Whitehouse Waste Oil Pits Site

Jacksonville, Duval County Florida

March 2001

EPA APPROVES REMEDIAL DESIGN

Figure 1

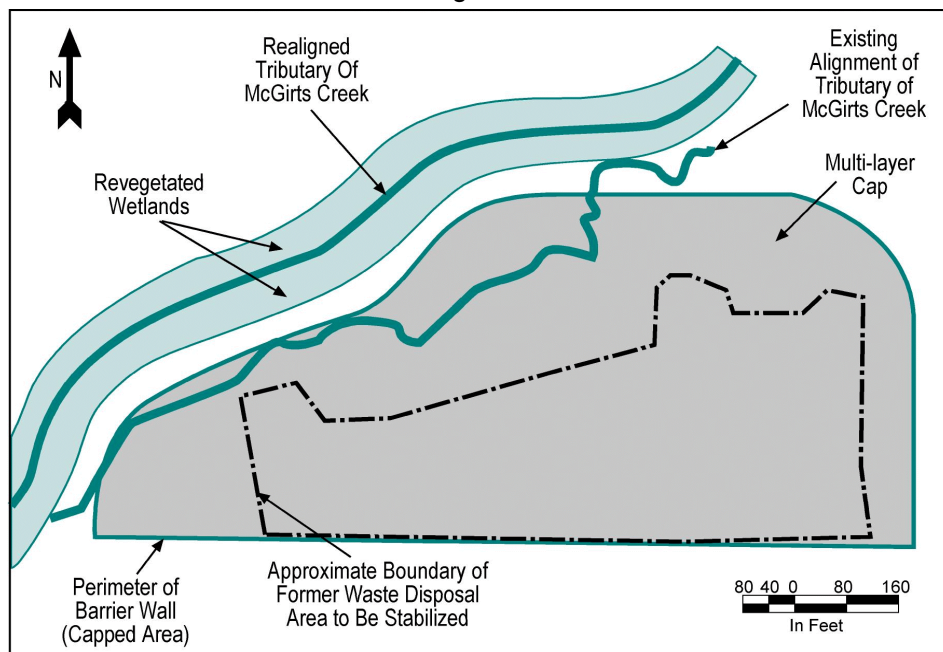
Vertical Barrier (Slurry Wall) - The slurry wall is longer and deeper than specified in the AROD. Sampling performed during the design phase revealed that groundwater contamination extends further west than previously known. As a result, the slurry wall in the final design encompasses additional contaminated groundwater both north and west of the Site. In addition, the results of the design investigation indicated that the slurry wall in the final design needs to extend to a depth of 55 to 65 feet, rather than 40 feet as estimated in the AROD, to ensure that the wall keys into the semi-confining unit.

Capped Area - The capped area has increased from 9 acres to 10.5 acres. The capped area is 17% larger than estimated in the AROD due to the increased size of the containment area.

Tributary Realignment - An additional 900 feet of the McGirts Creek tributary will be realigned. About 1,500 feet the creek will be realigned instead of the 600 feet estimated in the AROD because the cap and slurry wall were expanded to the North. No endangered plants or animals were encountered in the proposed construction areas during the ecological survey of the creek and surrounding wetlands. The final design includes features to improve the wetland habitat for plants and animals, as well as erosion control measures to protect the stream.

Figure 2 - Typical Cap Cross-Section

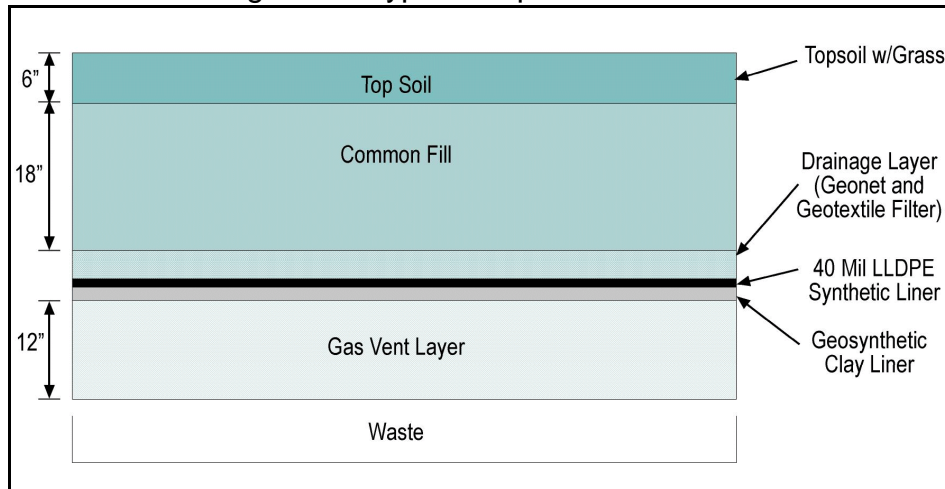
- Construction of a multi-layer cap over the contaminated area which meets the Resource Conservation and Recovery Act (RCRA) closure requirements. Figure 2 shows a typical cap cross-section. The cap will cover about 10.5 acres;
